**CITY OF MERCED PROJECT CP190043
CHANGE ORDER NO. 1**

PROJECT NAME: CMAQ (049) Motel Drive

REASON FOR CHANGE ORDER: Extra work for added driveways, curb and gutter adjustment to remove from joints, curb-ramp replacement with cross gutter, retaining curb for retaining soil behind new sidewalks, and modified fencing.

R STREET PLAN

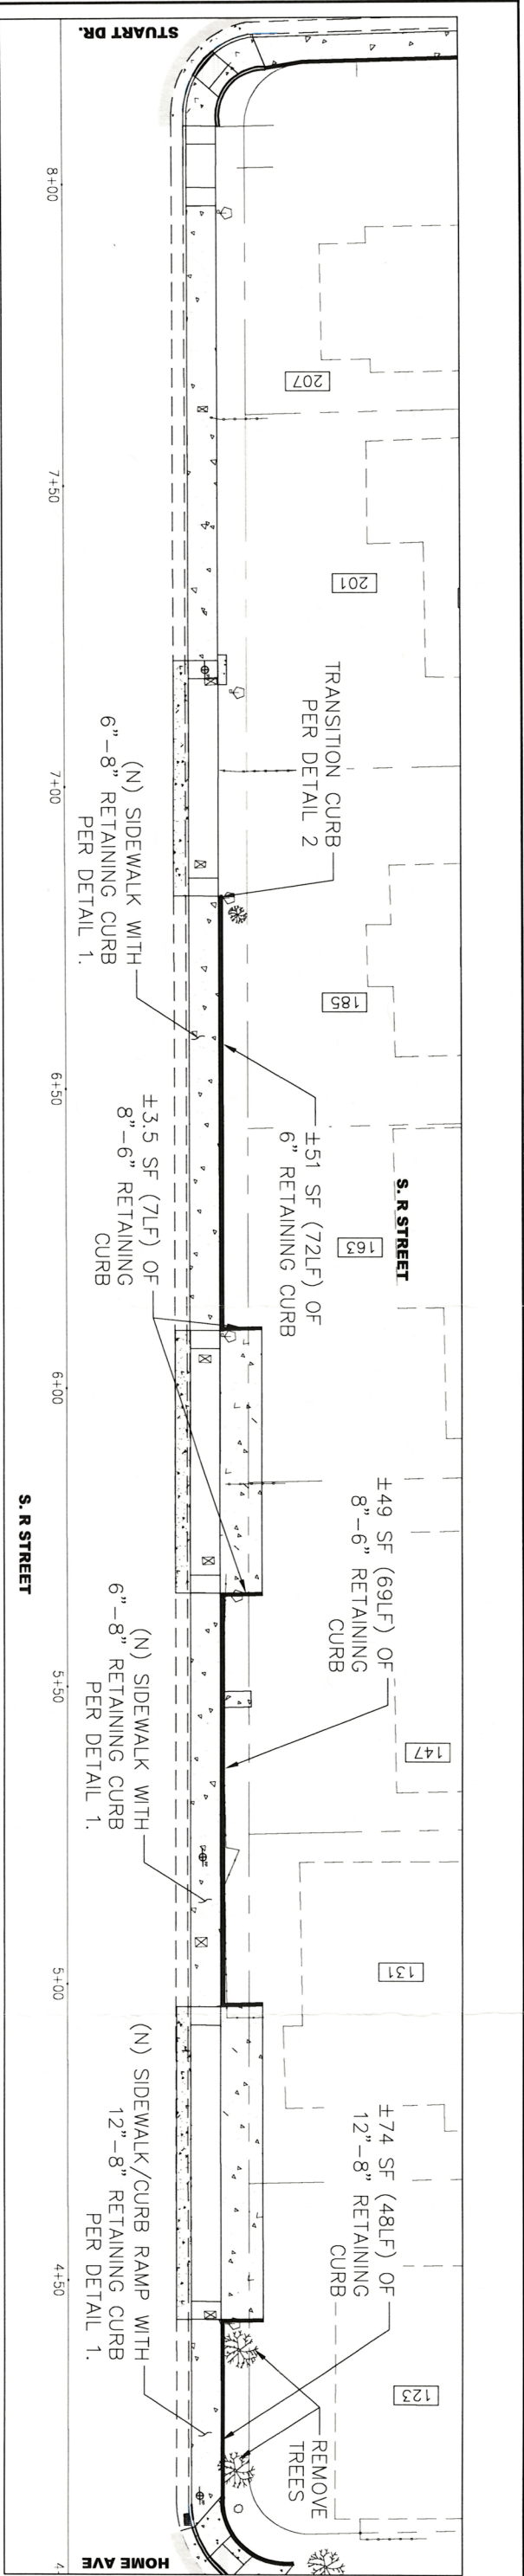
REVISION SIDEWALK WITH CURB

1 SIDEWALK WITH CURB
NTS

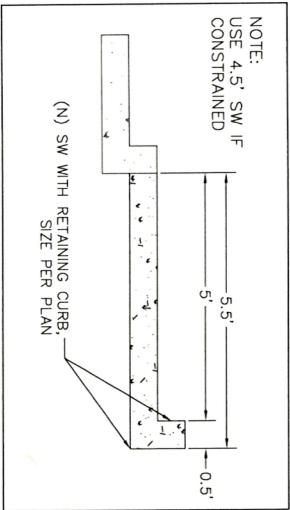
REVISION

SIDEWALK WITH CURB
